Permit Application Review Report
Date: 9/9/2026

Project Name: MSP Trucking

Project PAN: P-26-043

Project Purpose: Construction of a new warehouse building with parking and stormwater management features

Figure 3: Soils & Erosion Control

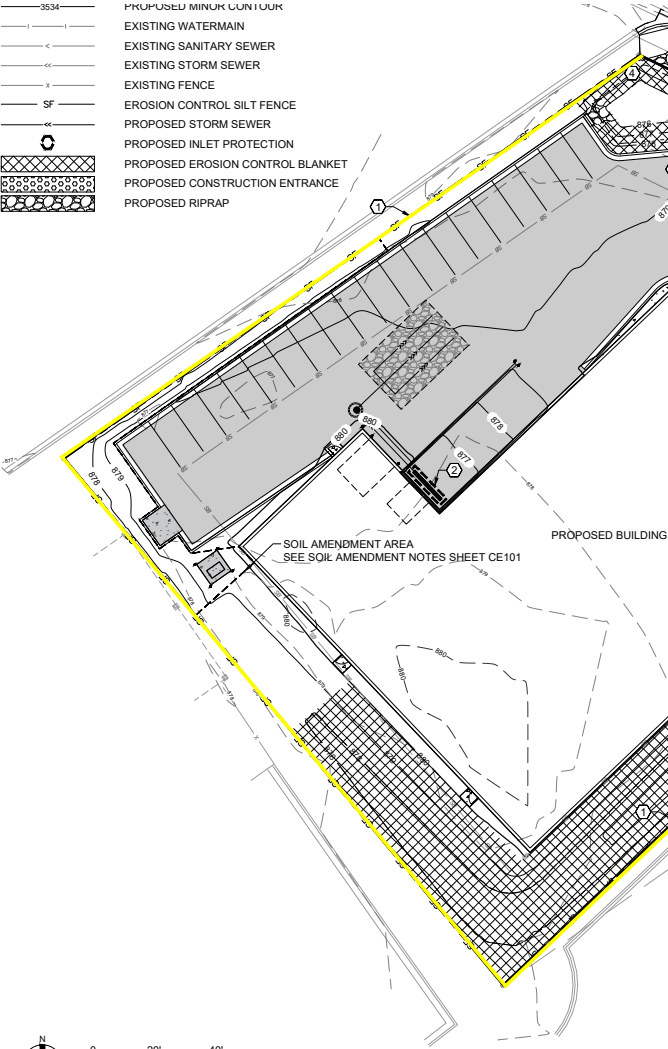
3. Updates the soils & erosion control plan to include the following:
 - a. A note to stabilize soils and soil stockpiles within 24 hours of inactivity.

- b. Show perimeter surrounding the infiltration basin to prevent compaction during construction.

The proposed project drains to Pleasure Creek. The soils affected by the project include Seelyeville and Isanti which have a soil erodibility factor of 0.15 or greater. Disturbed areas are not proposed to be stabilized within 24 hours, as required. The proposed erosion and sediment control plan includes stabilized construction entrance, perimeter control, street sweeping, and inlet protection. The erosion control plan does not meet District requirements because soils and soil stockpiles are not proposed to be stabilized within 24 hours and infiltration basins do not have perimeter control to prevent compaction during construction. The site does require an NPDES permit. See attached Figure 3: Soils and Erosion Control Plan.
